SERVICE BULLETIN

REFERENCE	TRANSMISSION & CLUTCH
NUMBER	017
DATE	09-29-89
MODEL	SV, ST, AW with A140E

A14#E VALVE BODY STRAINER

NO.1 SOLENOID MOUNTING BOLT
INTERFERES WITH NEW STRAINER
P/N 35330-20011 INSTALLATION

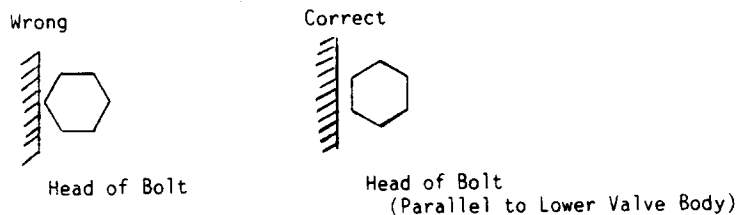
When replacing the Valve Body Strainer (P/N 35330-20011) on vehicles equipped with the A14#E A/TM, you may encounter contact between the strainer and the number 1 shift solenoid mounting bolt (see illustration).

In order to reduce the contact between the solenoid mounting bolt and the strainer, the head of the bolt must be positioned as shown below.
